Commonwealth Edison Company

August 31, 1971

Subject: Proposed Change No. 14 to Appendix A,
DPR-19, AEC Dkt 50-237

TRANSIENT ANALYSES OF PROPOSED TESTS FOR WHICH A TEMPORARY WAIVER OF FLOW
REFERENCED SCRAM IS REQUESTED AND A FIXED 120% APRM FLUX SCRAM IS PROVIDED

Fig 2E-2

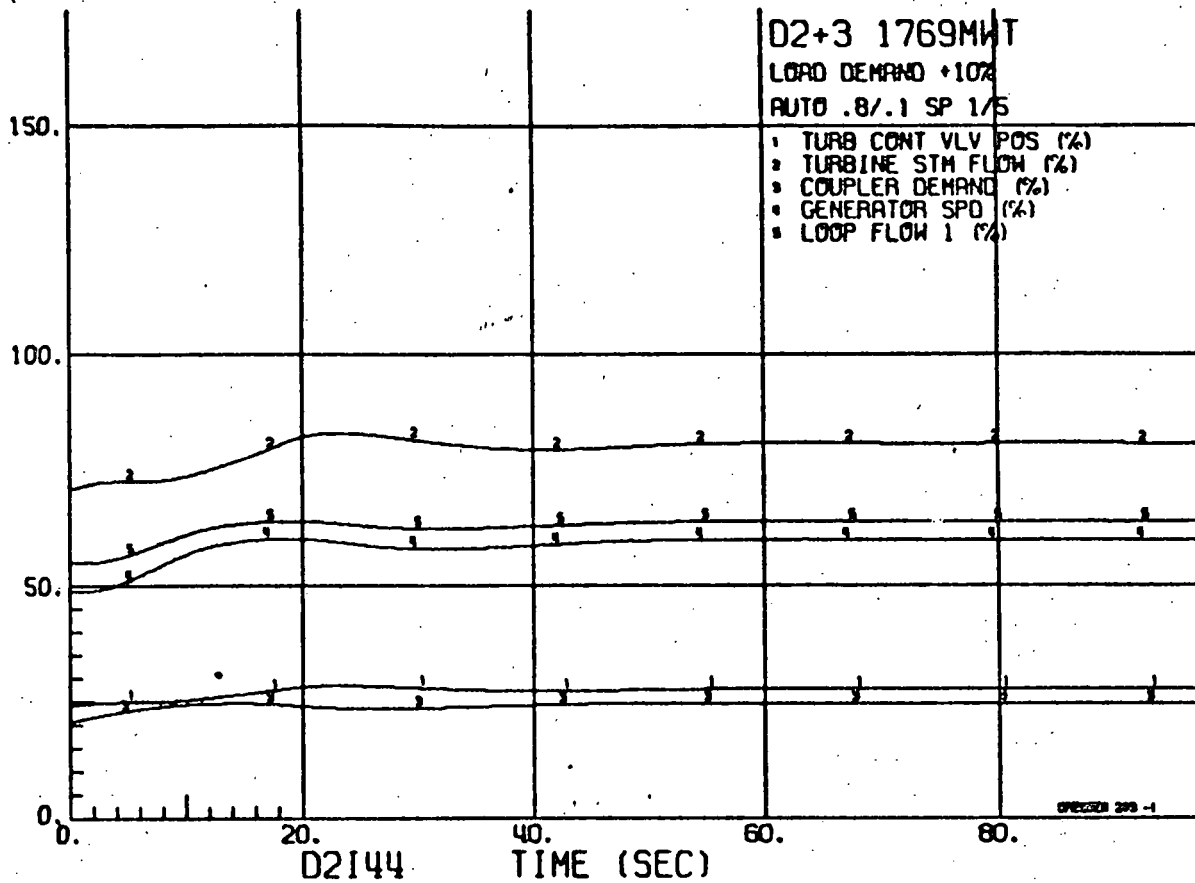
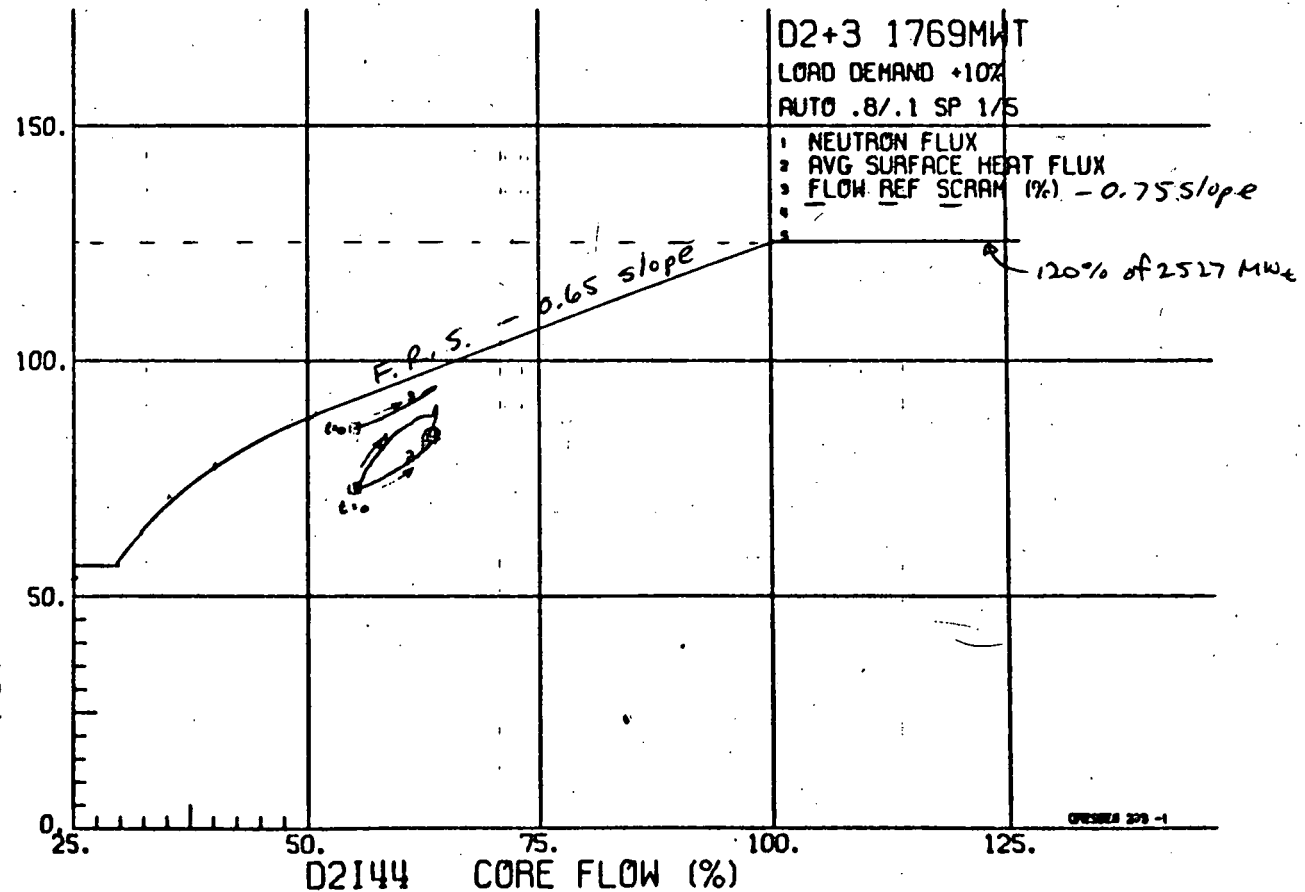
Figures 2E-1 and 2E-2 show the expected response to a 10% load demand step increase with the settings of both the master flow controller and the transient setpoint adjuster at the expected optimum values. On the top plots of Figure 2E-2, note that the turbine steamflow response, (the parameter being optimized in these tests), is such that the 10% increase is reached within the desired 20 seconds.

Fig 2F-1

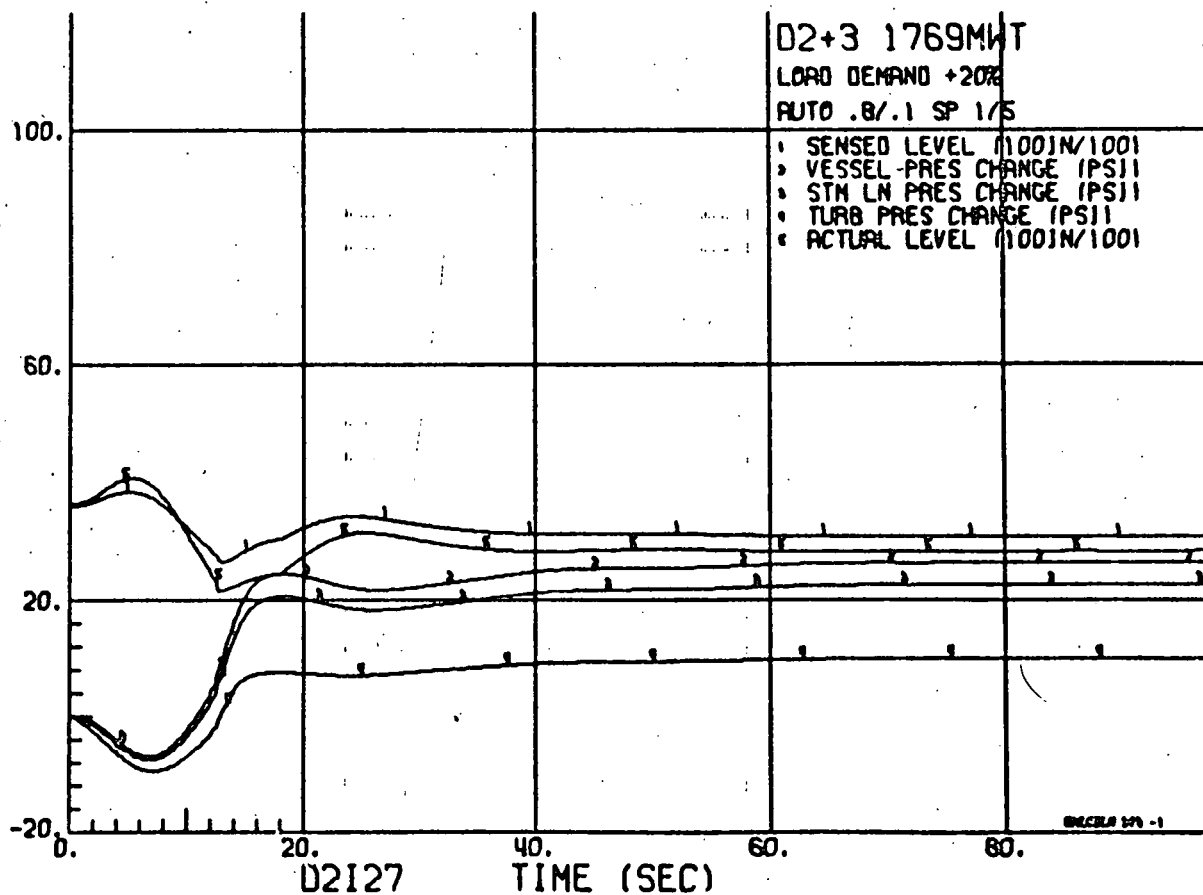
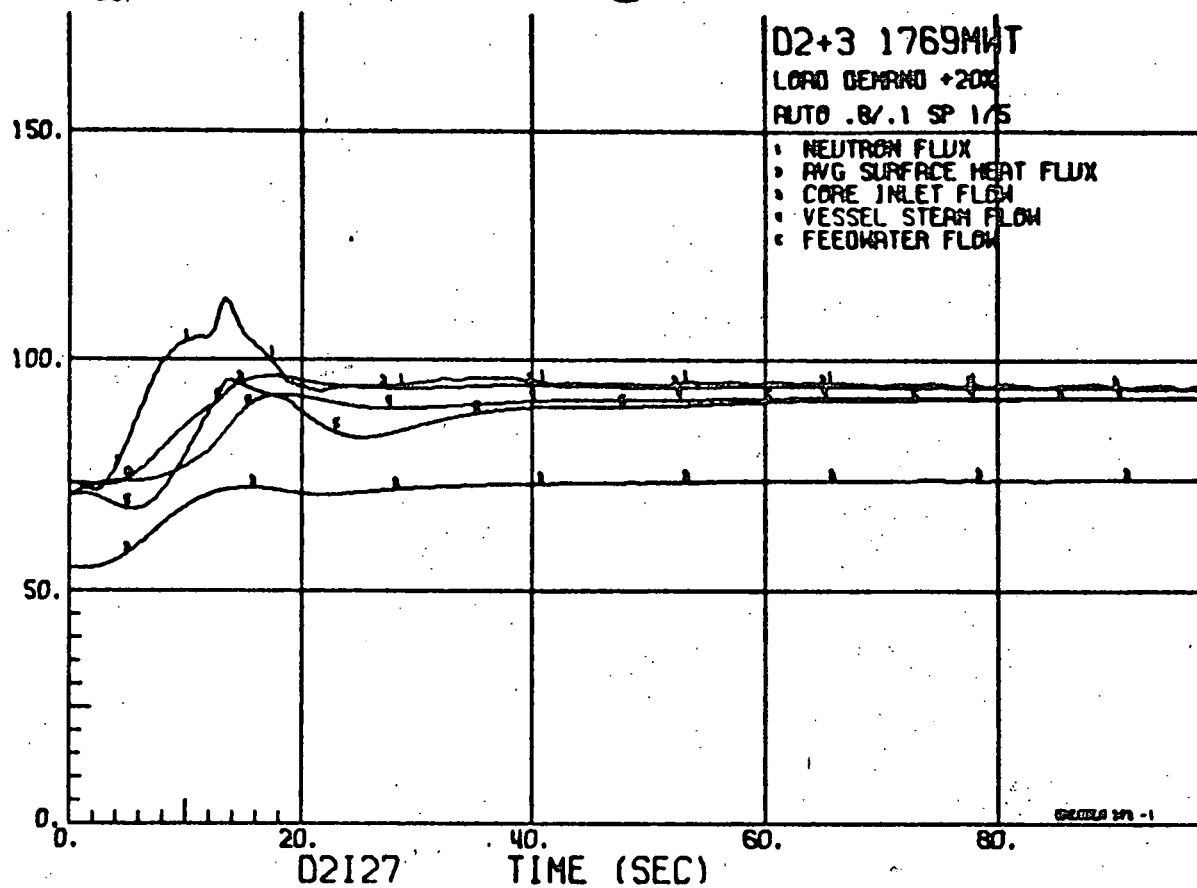
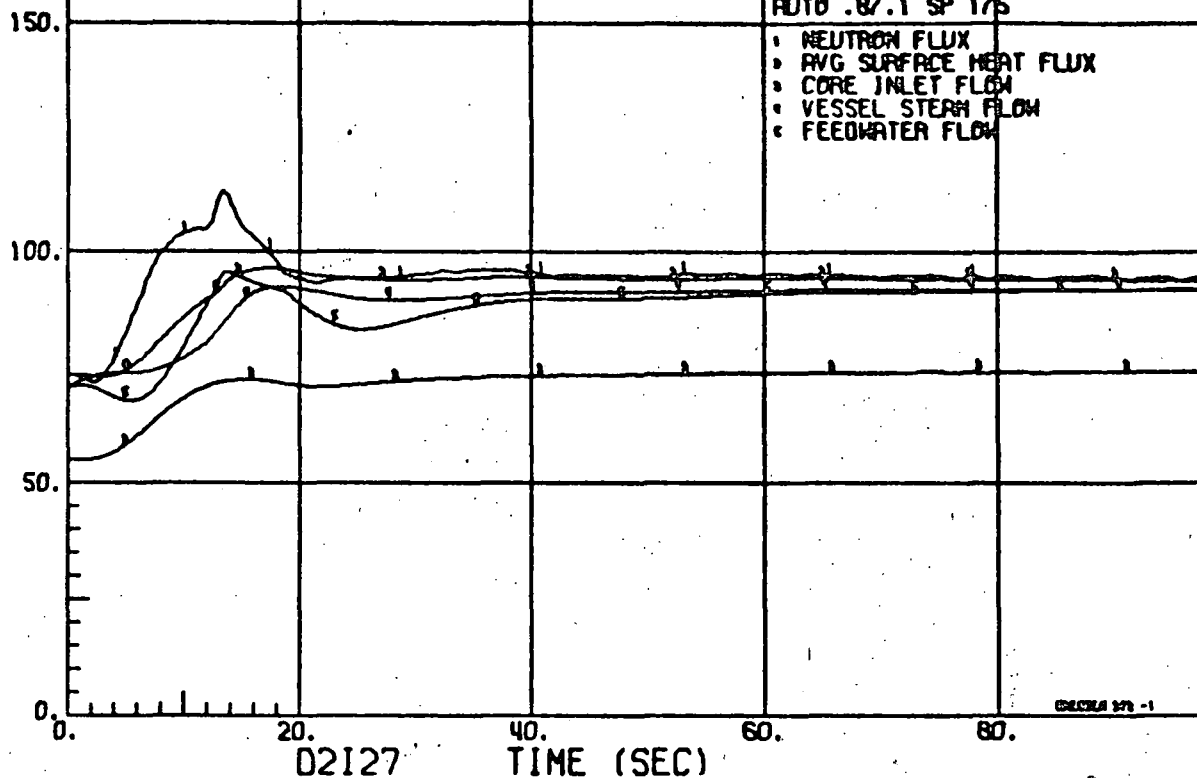
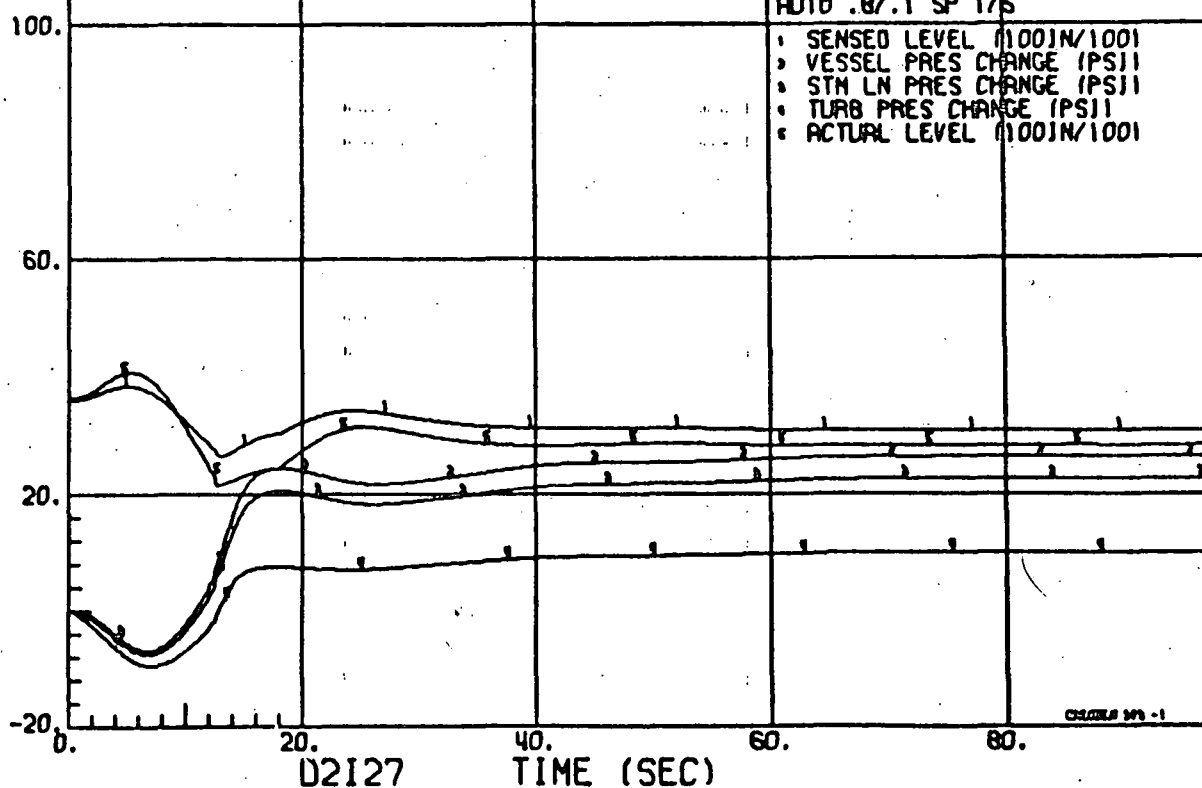
Figures 2F-1 and 2F-2 show the expected plant response to a 20% load demand step increase with the settings of both the Master Flow Controller and the transient setpoint adjuster at the expected optimum values. The dashed lines on the top plots of Figure 2F-2 represents the desired minimum response to a 20% load demand step of approximately 1.0% per second for the first five seconds with a following rate of 0.5% per second for the next 30 seconds until the full 20% increase is achieved. Flow referenced scram interference is predicted for this transient. Note on the bottom plots of Figure 2F-2 that average surface heat flux lags behind the neutron flux increase and proceeds upward along the 100% load line with only a slight overshoot (approx. 5%). This transient represents the fastest increase in power expected to be reached in the proposed test program. Reference should be made to the analyses of the failure of a recirculation loop speed controller which appears in Section 4.3.3.1 in the Dresden Unit No. 2 FSAR and to Figures 4.3.9a and 4.3.9b in the FSAR. Note that the 20% load demand increase transient falls well within the analysis of the speed controller failure. The latter transient was shown in the FSAR and shows the reactor to be adequately protected by the action of a fixed 120% APRM flux scram.

Fig 26-1

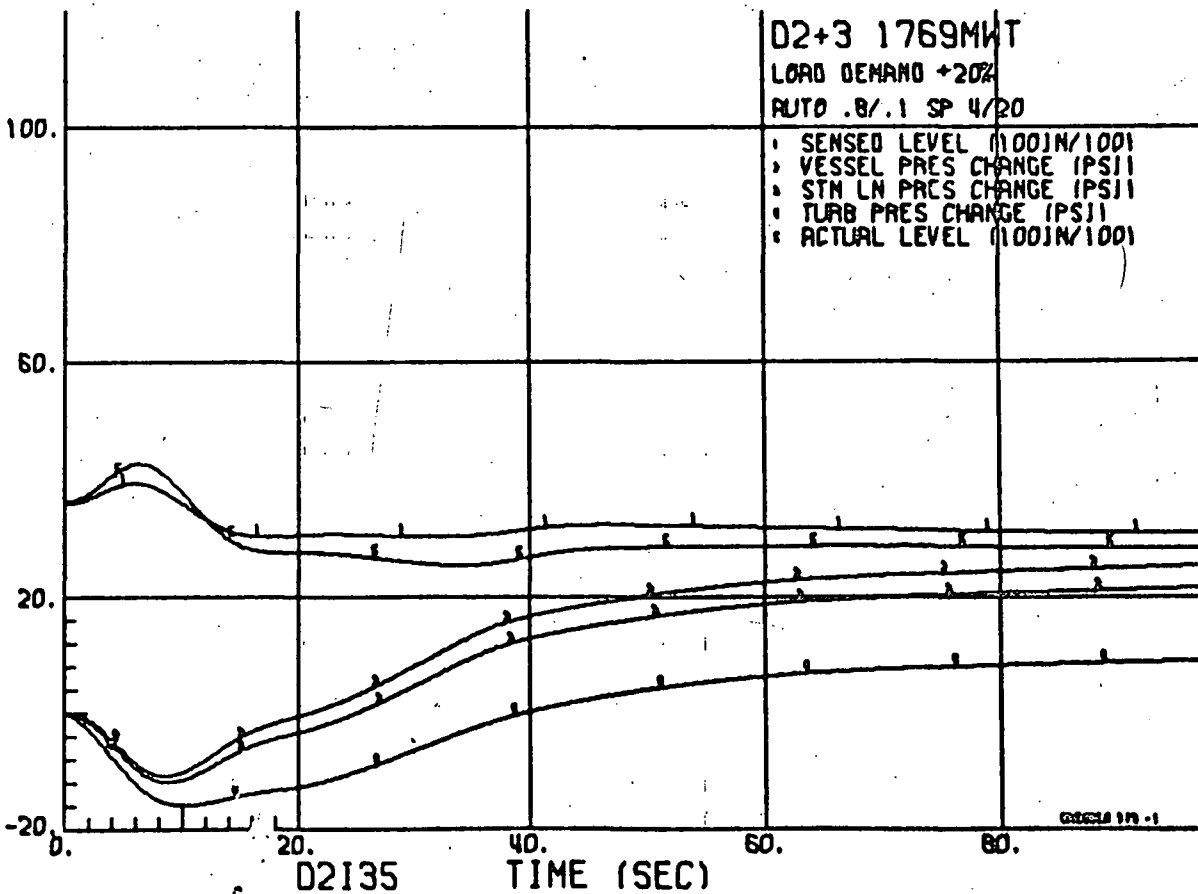
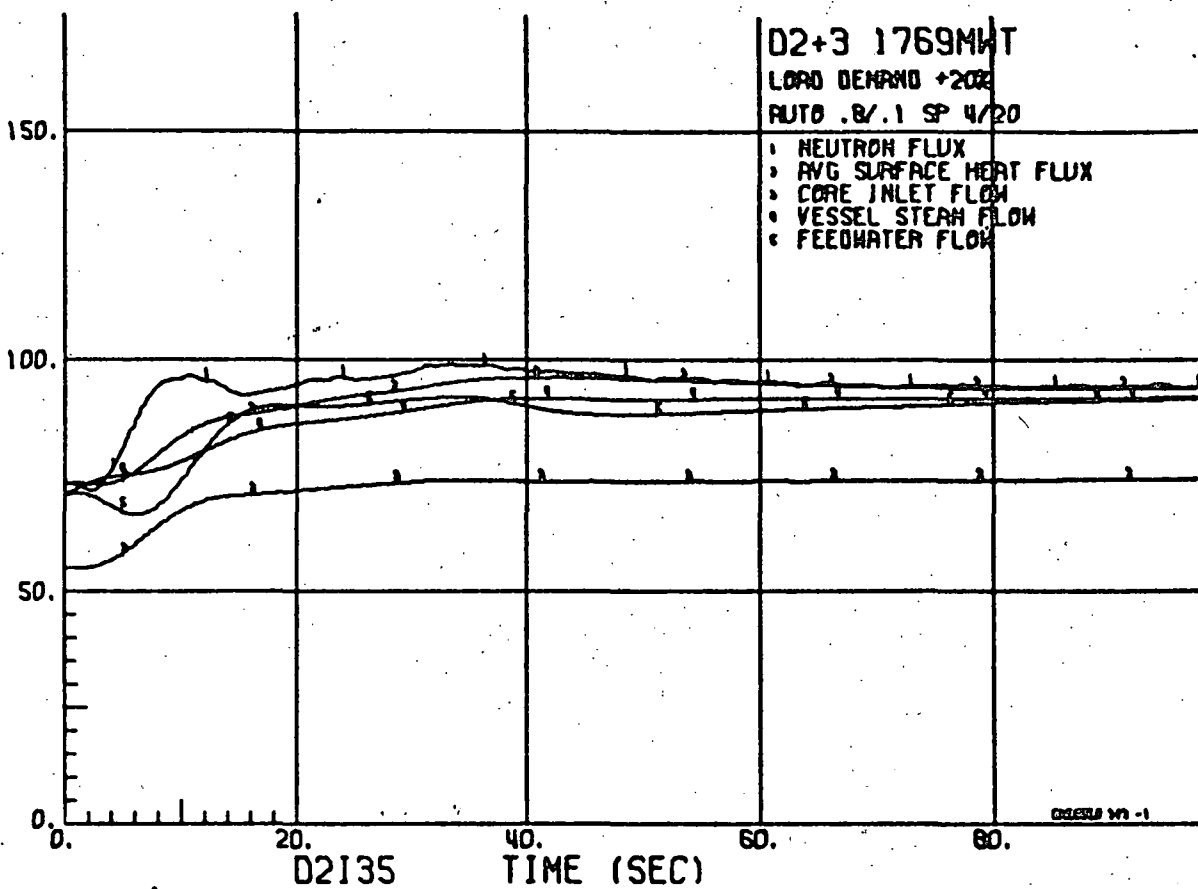
Figures 2G-1 and 2G-2 show the expected response to a 20% load demand step increase with the settings of proportional and reset gain of the master flow controller at the expected optimum values but with the gain and time constant of the transient setpoint adjuster at values that just barely result in a response that satisfies the desired 1.0% per second for the first five seconds with a 0.5% per second following rate. Again, the proximity of the flow referenced scram line should be noted.

Fig 3A-1

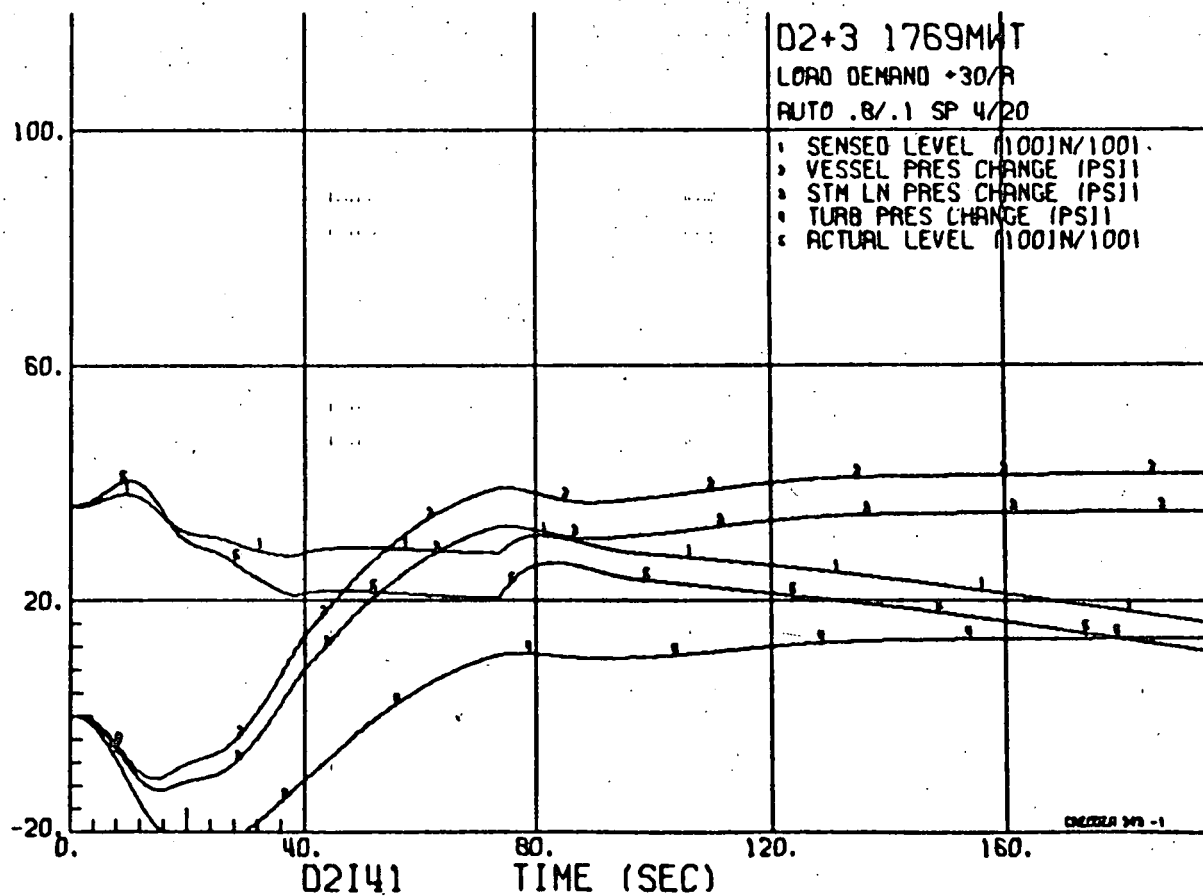
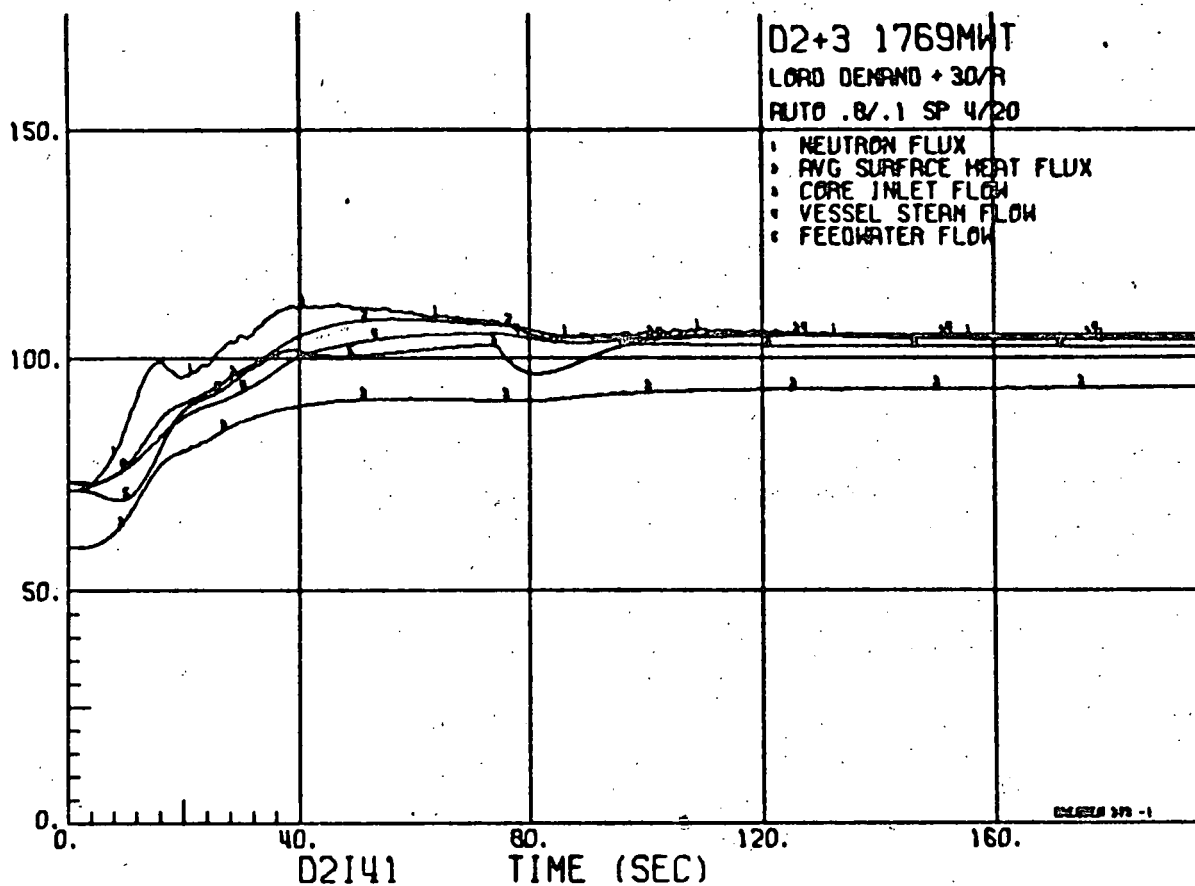
Figures 3A-1 and 3A-2 show the plant response to a 30% ramp increase in load demand at a demand rate of $2 \frac{1}{2}\%$ per second. The ^{dashed} dsched line on the top plots of Figure 3A-2 shows the minimum desired response to a 30% ramp demand of 0.5% per second. Again, note the proximity of the flow referenced scram line. *

The $\pm 3\%$ per minute load changes are at a rate much less than the capability of the flow control system. As seen on Figures 3A-1 and 3A-2 the response rate can be as large as 0.5% per second or 30% per minute. All tests performed to demonstrate the $\pm 3\%$ per minute capability over the load range from 15% to 100% will have responses that fall well within the analysis of the 30% per minute response shown on Figures 3A-1 and 3A-2. Only those tests that approach the 30% per minute response rate are expected to show interference by flow referenced scram.
